Groundwater and Wastewater Services File Imaging Project

INDIVIDUAL WATER AND WASTEWATER SYSTEMS PROGRAM
APPLICATION FOR SERVICES

TAX/PARCEL NUMBER: 011-012-09

STREET ADDRESS: 16204 Old Statesville Rd

PROPOSED PLOT PLAN

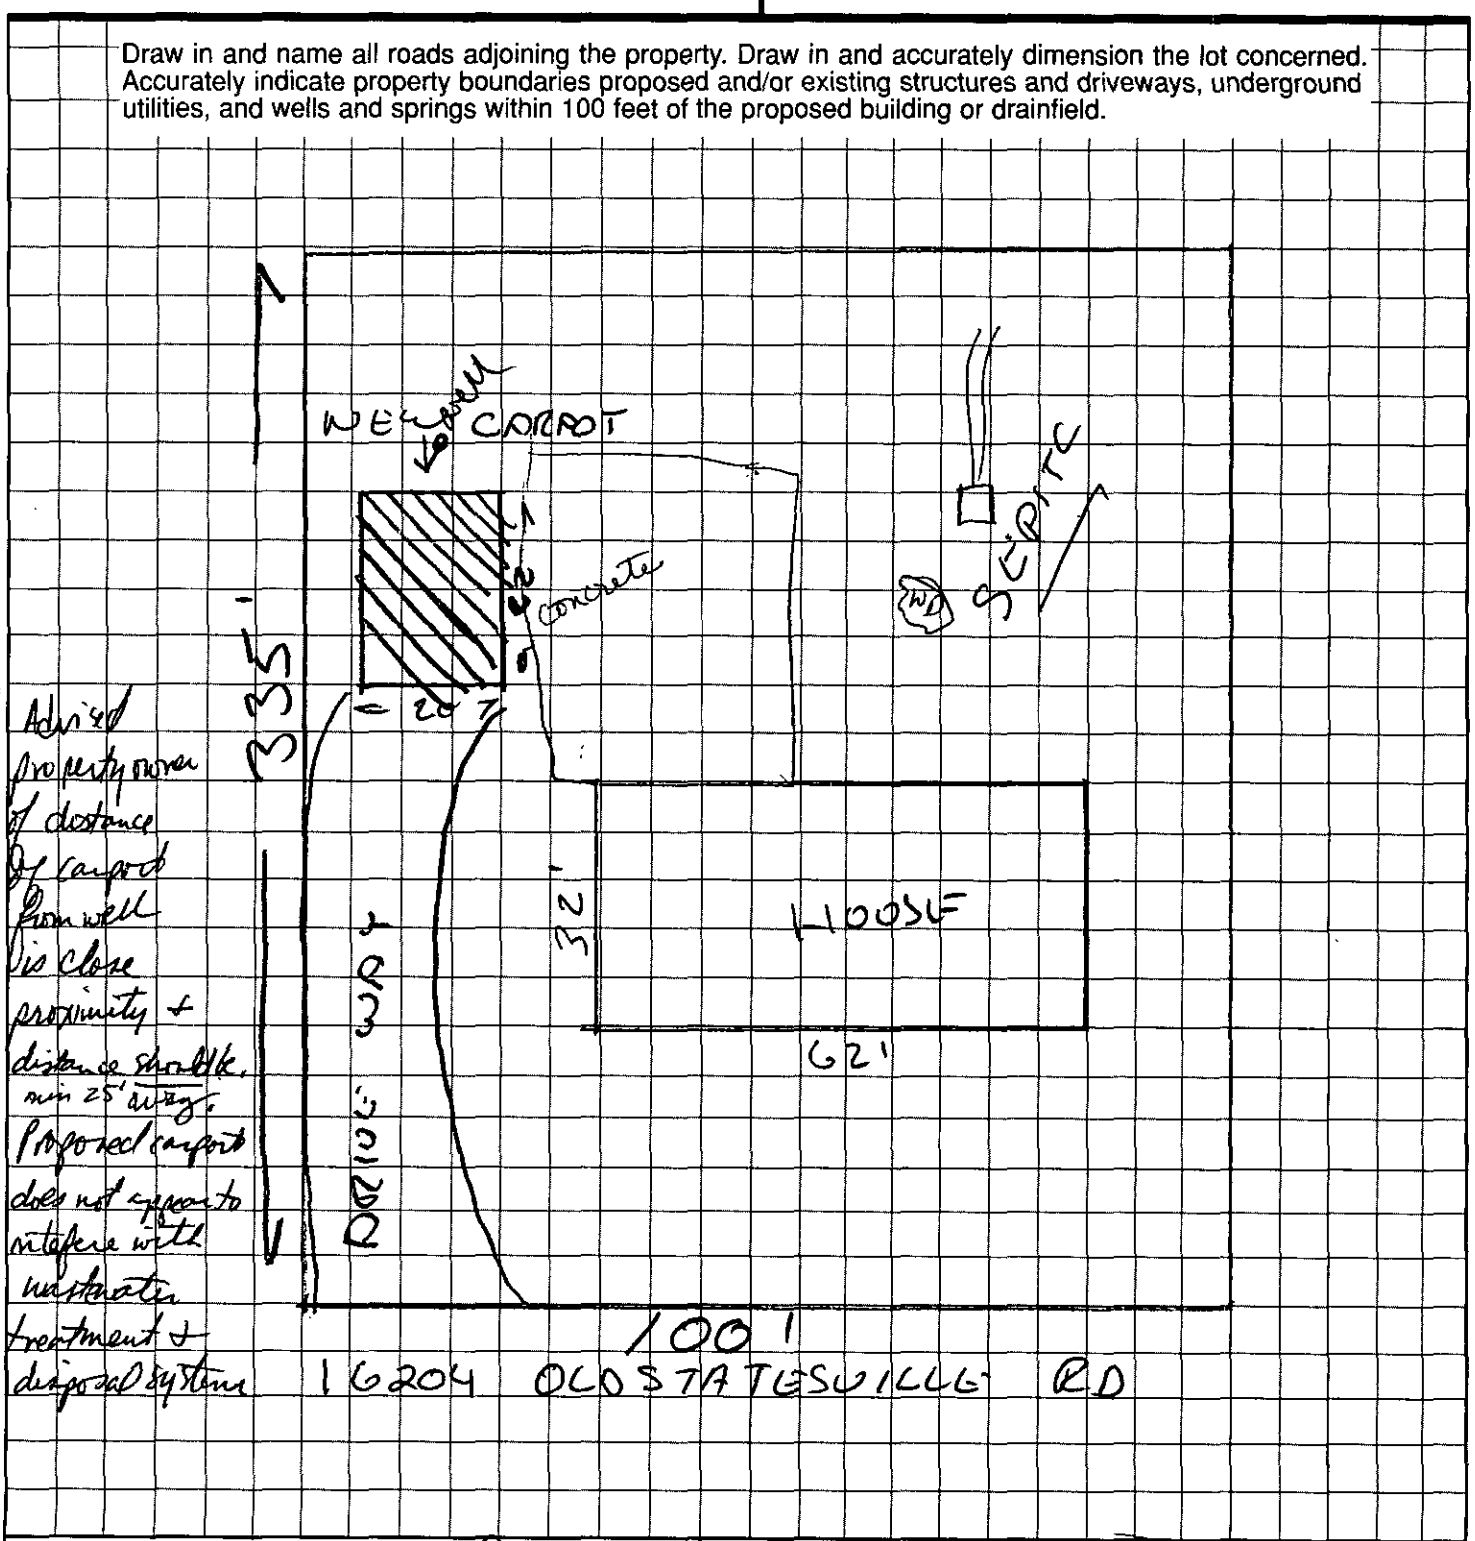
Advised property owner of distance of carport from well. Is close proximity & distance should be min 25' away. Proposed carport does not appear to interfere with wastewater treatment & disposal system

...VR existing system. Proposed carport to stay min 5' from any part of wastewater treatment & disposal syste
